## ■ ATF (AUTOMATIC TRANSMISSION FLUID) WS

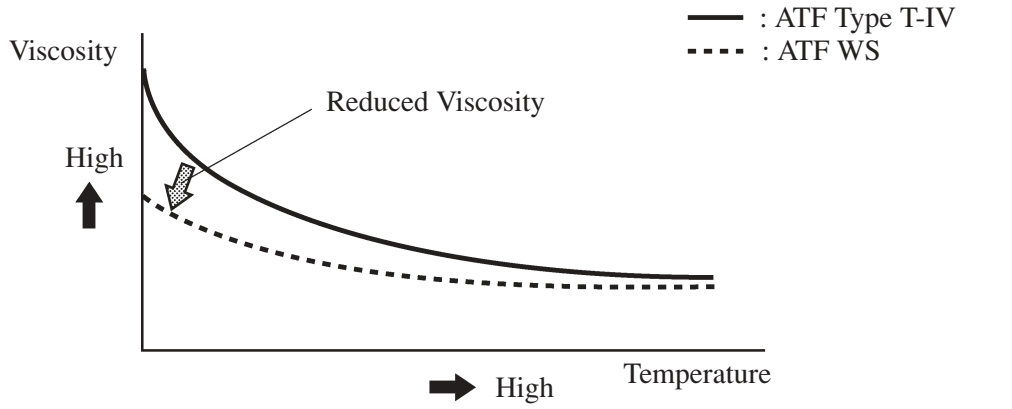
- The ATF WS is used to reduce the resistance of the ATF and ensure fuel economy by reducing its viscosity in the practical operation range. At the high-temperature end, its viscosity is the same as that of the ATF Type T-IV, which ensures the durability of the automatic transaxle.
- There is no interchangeability between the ATF WS and other types of ATFs (ATF Type T-IV, D-II).

- The color of the ATF level gauge used in the ATF WS has been changed to black. (Orange was used in the ATF Type T-IV on the previous model.)
- If a vehicle with a transaxle filled with ATF WS is replenished with another type of ATF, the vehicle might not start off at extremely low temperatures.
